Roads Design and Construction Division  
Room 331  
City Hall  
Cork

**Re: Cork Docklands to City Centre Road Network Improvement Scheme**

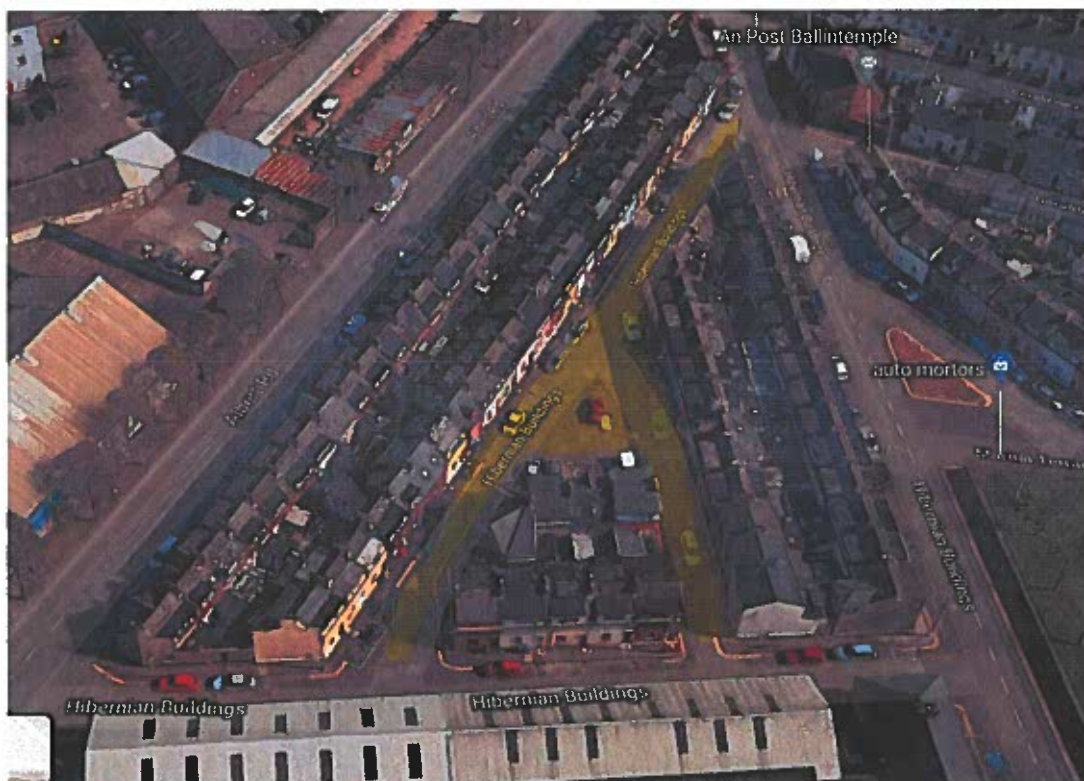
Furthermore, we note the proposal to maintain vehicular access through Hibernian Buildings. Given that alternative routes are available for vehicles, we ask that the option of pedestrianising the triangle (highlighted in yellow below) and/or turning the area into a public outdoor space for locals to enjoy is explored with local residents while retaining some local parking options.
